**Subject:** High Cragwell, Aislaby.

I now attach revision 4 and would advise as follows.

Proposed House Alterations  
 High Cragwell,  
 High Cragwell, Aislabey. YO21 1SZ.  
 for Mr and Mrs Pearson.

scale 1/100 at A1 drwg no p1 3/11/21 rev 19/11/21  
 rev 25/1/22 rev 11/2/22 rev 15/2/22

Ground Floor / Site Plan

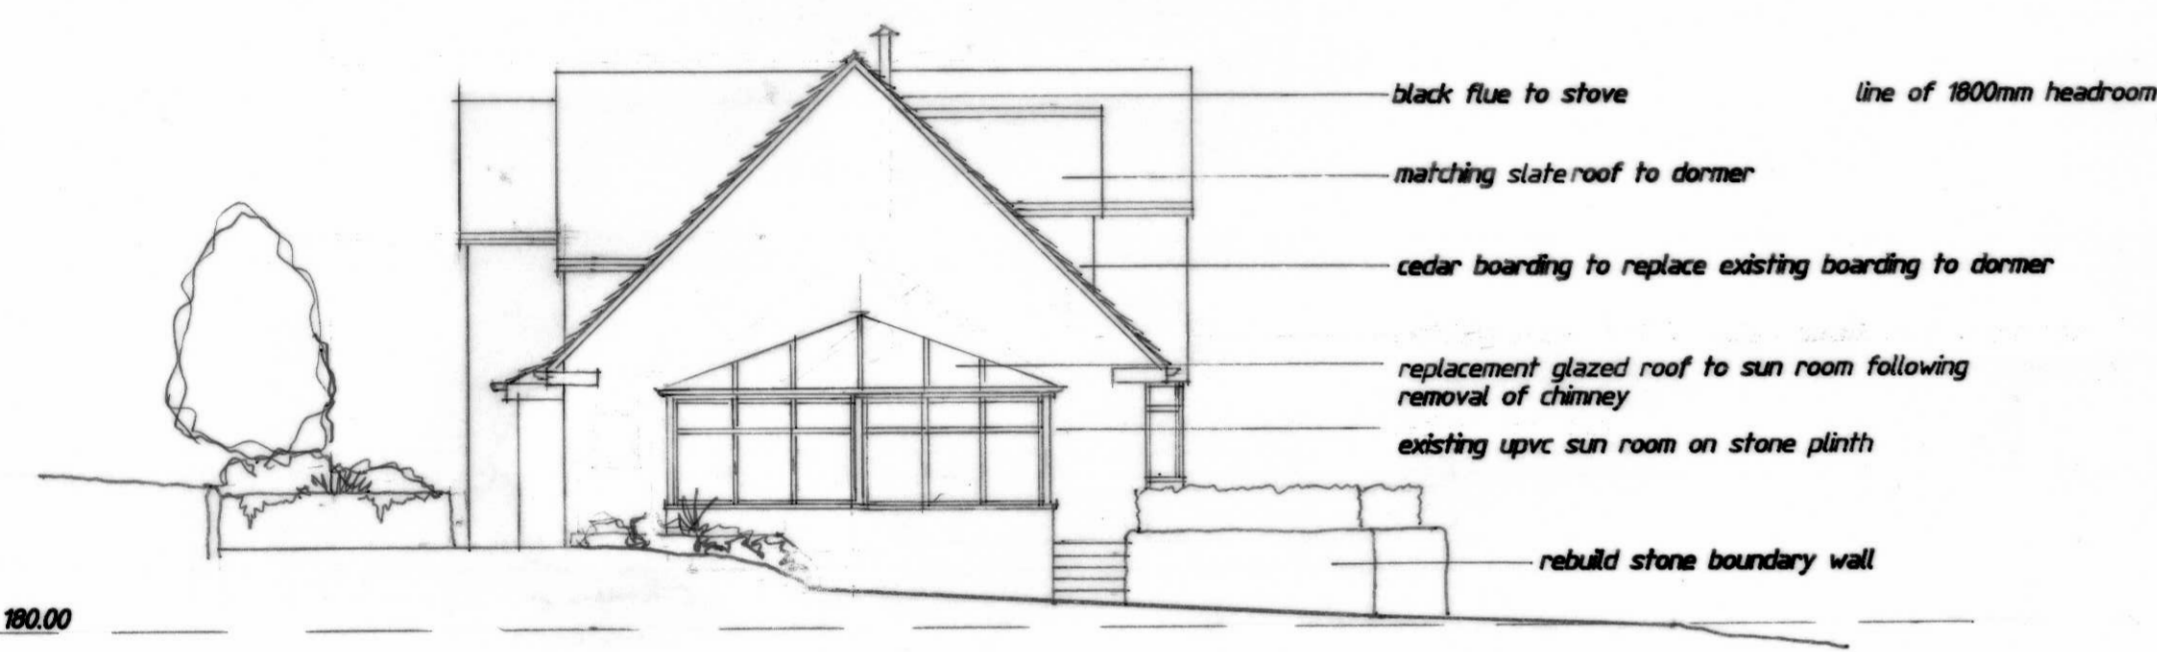
I have reinstated the glazed roof to the sun room – this will probably have to be replaced when the chimney is removed and glass will be used rather than polycarbonate.

I have indicated a screen between the sun room and the dining room to comply with Building Regulations on heating.

I have extended the kitchen under the loggia.

The wood stove has been moved between the dining room and reception room which will remove the exposed flue from the gable.
